SUNDRY NOTICES AND REPORTS ON WELLS
Do not use this form for proposals to drill or recomplete an abandoned well. Use form 3160-3 (APD) for such proposals.

8. Well Name and No.
CEDAR LAKE FEDERAL CA 302H

APACHE REQUEST A VARIANCE TO USE A FLEXIBLE HOSE BETWEEN BOP & CHOKE MANIFOLD

**PECOS DISTRICT
CONDITIONS OF APPROVAL**

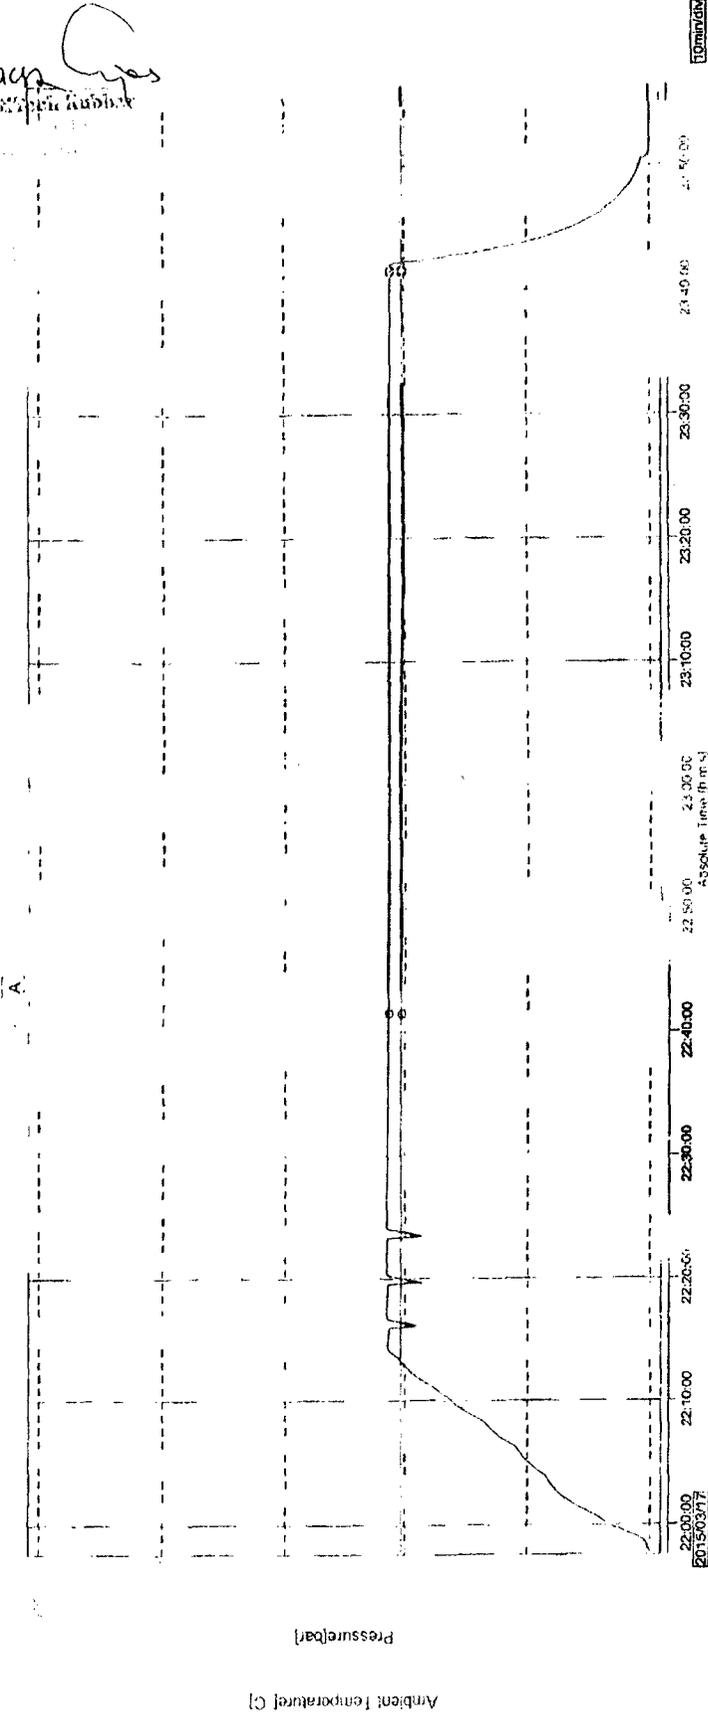
Manufacturer: Continental
SN: 69915
ID: 3"
WP: 10,000psi
TP: 15,000psi

1. Variance approved to use flex line from BOP to choke manifold. Check condition of flexible line from BOP to choke manifold, replace if exterior is damaged or if line fails test. Line to be as straight as possible with no hard bends and is to be anchored according to Manufacturer's requirements. The flexible hose can be exchanged with a hose of equal size and equal or greater pressure rating. **Anchor requirements, specification sheet and hydrostatic pressure test certification matching the hose in service, to be onsite for review. These documents shall be posted in the company man's trailer and on the rig floor.** If the BLM inspector questions the straightness of the hose, a BLM engineer will be contacted and will review in the field or via picture supplied by inspector to determine if changes are required (operator shall expect delays if this occurs).
